Maria Del Mar Arribas-Colon, M.S.
Project Manager, NMSS/MSTR/MSLB
U.S. Nuclear Regulatory Commission
301.415.6026

Subject: Response to Questions, 26-April-2017 from Tomas Herrera, re: 31-Mar-2017b **Amendment Request to Mirion Technologies SS&D NR-1147-D-101-S**

TABLE 1:
CDM-21 / IDC COMPARISON

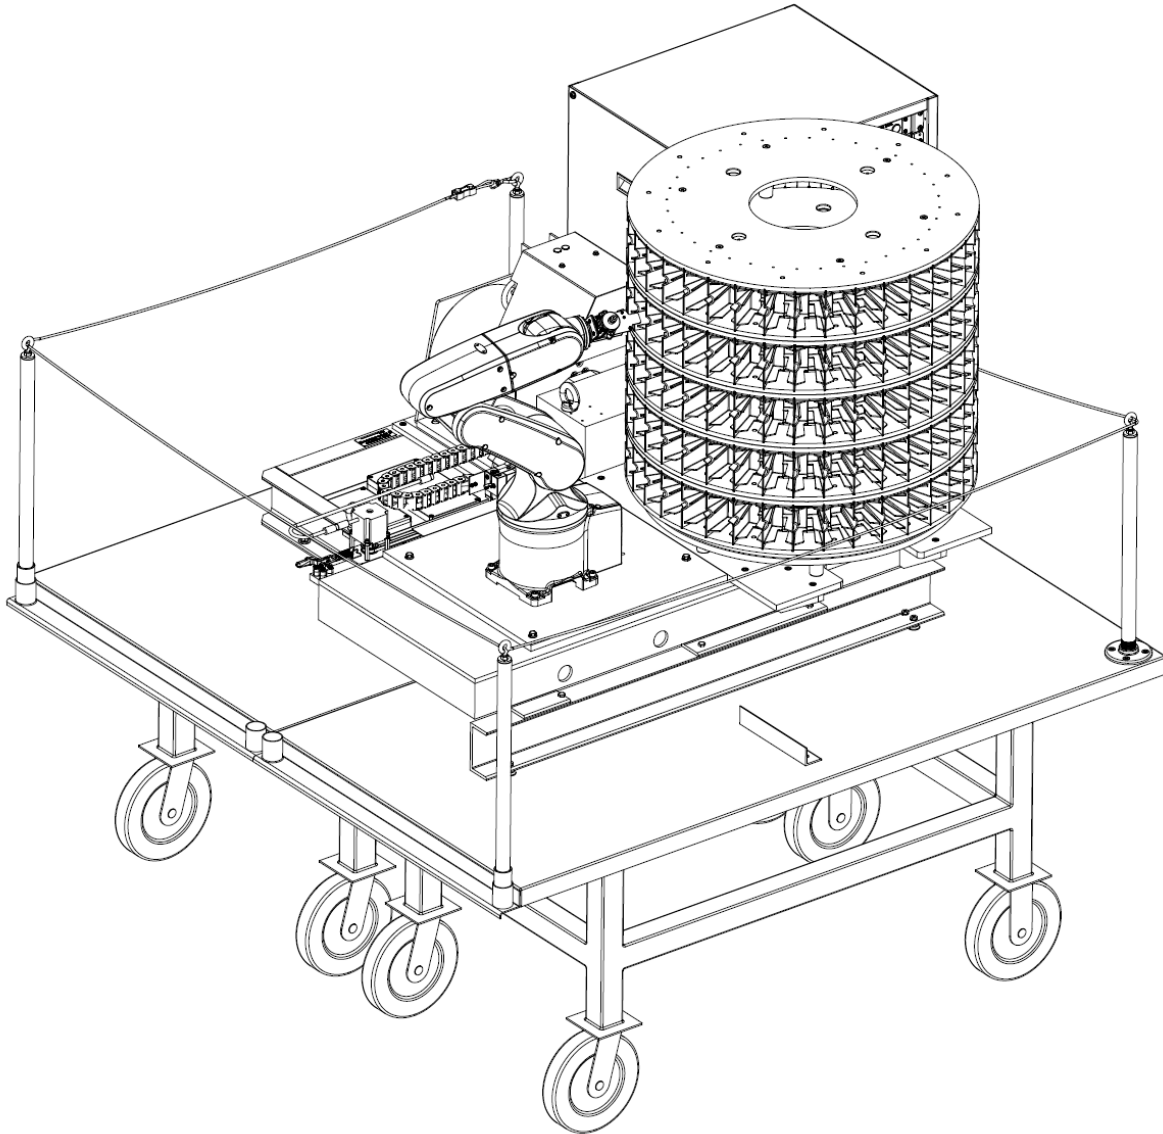
NRC Question	Mirion Response
<p>1. In your amendment you requested to use the P04 Series of sources in MGP Instruments calibration systems. Please confirm that the model number of the new source that will be used in the CDM-21 and IDC Intelligent Dosimeter Calibrator is the Cs7.P04.</p>	<p>The source model as provided by Eckert and Ziegler is shown below:</p> <p>Description: P04 Series Capsule Item Number: CS7P040001C, Model Cs7.P04</p> <p>See Attachment 1: E&Z Quotation Mirion Technologies Cs7PO4.pdf</p>
<p>2. Besides the changes summarized in your amendment request, please confirm that there are no other changes in the design and description of the calibrator as summarized in NR-1147-D-101-S. If there are more changes please identify those changes and how they compare to the originally distributed CDM-21 calibrators, preferably in a table format.</p>	<p>There are no mechanical changes to the core components of the IDC – Irradiator (source shield) Unit, Attenuator (filter) Disk and Slide Shield – which would affect (diminish) the radiological profile of the system. The Slide Shield is the exposure chamber for the dosimeter</p> <p>The Control Unit (control I/O boards and power supply) was updated with newer housing and components. A newer, optional multi-axis robot was implemented to replace the aging single-axis arm.</p> <p>See Table 1: CDM-21/IDC COMPARISON</p>

<p>CDM-21:</p> <p>Image shown is the core CDM-21 system (Option Robot and Dosimeter Magazine not shown).</p> <p>Original CDM-21 design for manual operation of dosimeter insertion into slide shield.</p>	
<p>IDC:</p> <p>Image shown as a complete system with Denso Robot, Carousel and updated Control Unit (Black box).</p> <p>No mechanical changes to Irradiation Source Shield, Attenuator Disk and Slide Shield (dosimeter exposure chamber) thus radiation profile remains unchanged.</p>

IDC COMPLETE SYSTEM: PERSPECTIVE

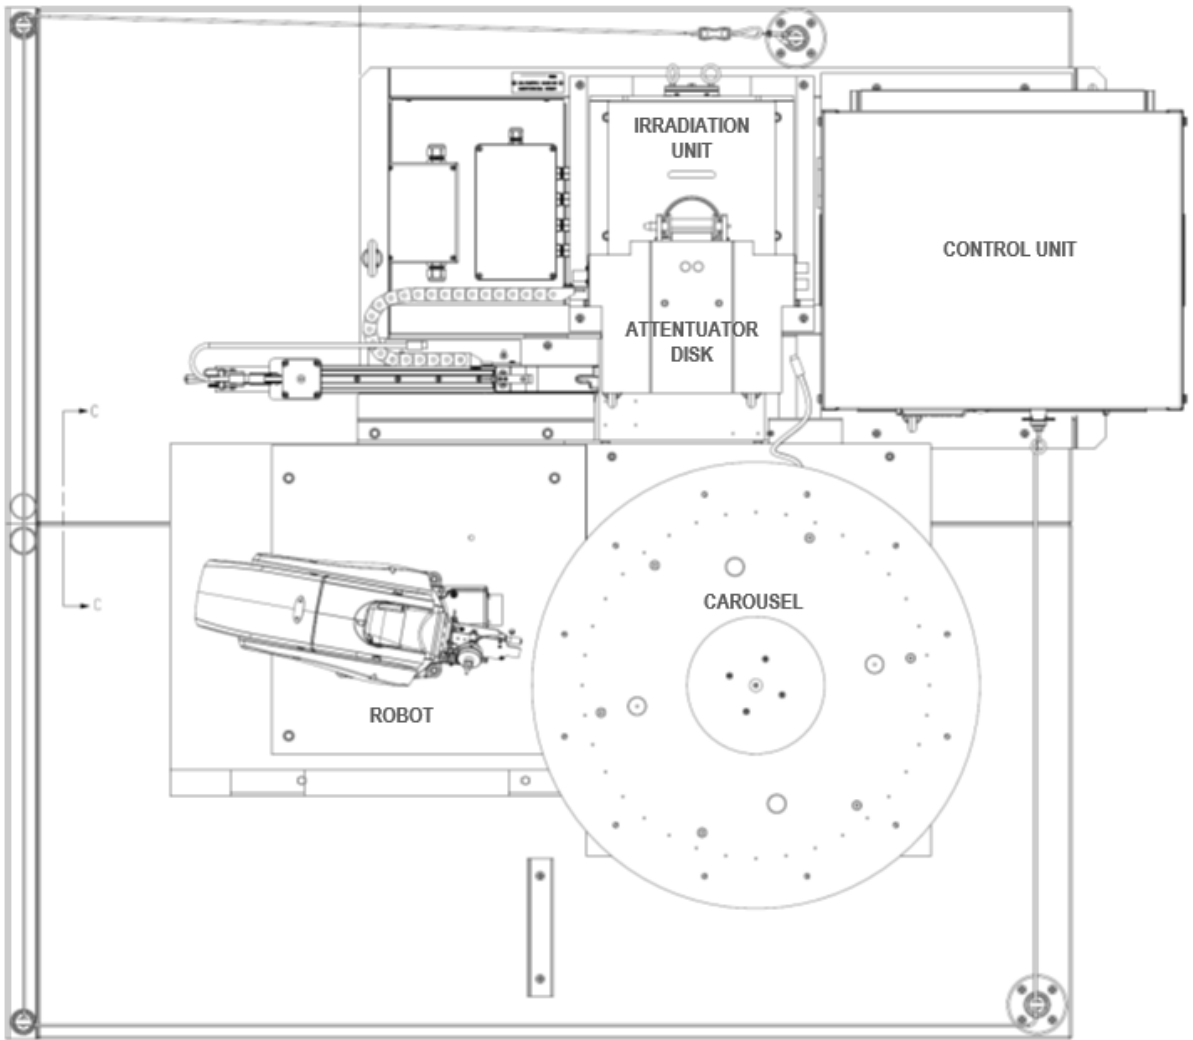
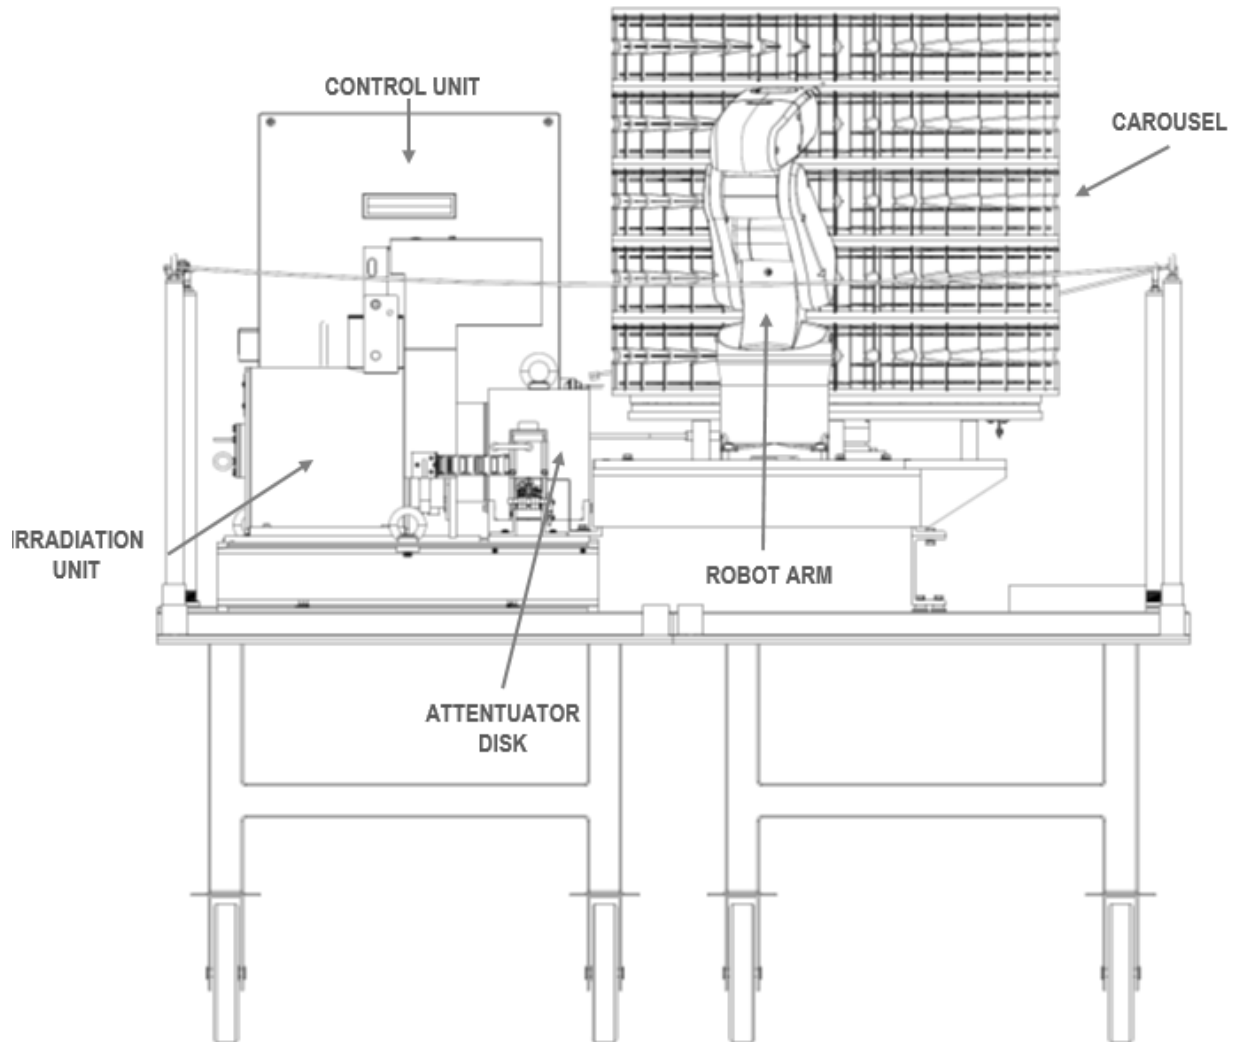
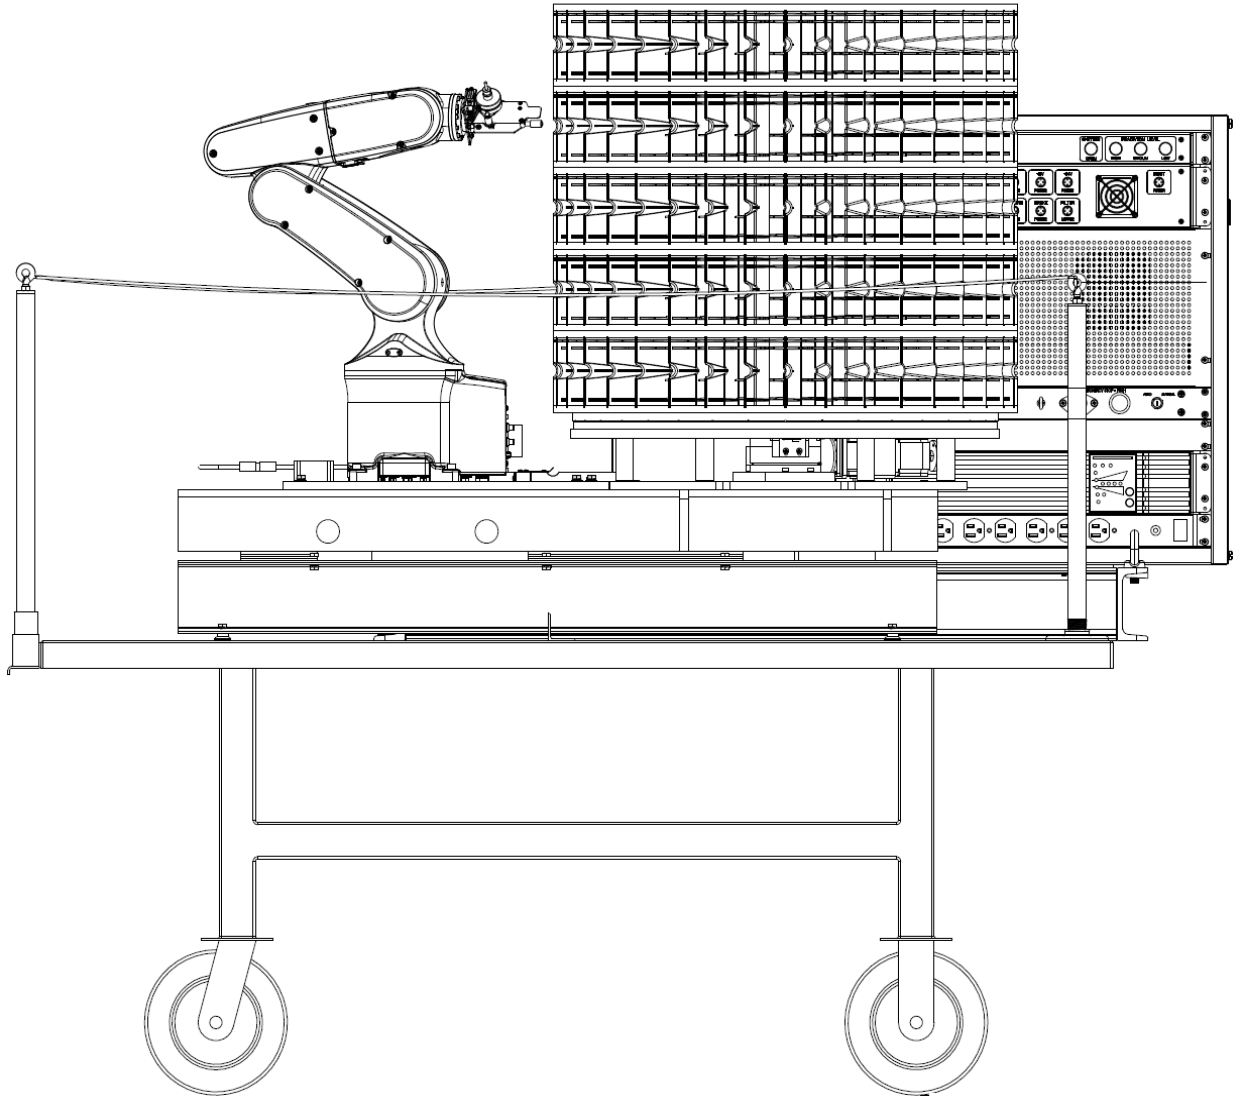
<p>3. Please confirm that there have been no changes to the MGP Instruments quality assurance program.</p>	<p>The Quality Assurance Program has not changed since issue of the SS&D and continues to endorse 10 CFR Part 50, Appendix B.</p>
<p>4. Please provide a picture of diagram of IDC Intelligent Dosimeter Calibrator, with the robotic arm so that it may be incorporated as an attachment to the registration certificate.</p>	<p>See attached drawings, Pages 4-7</p>
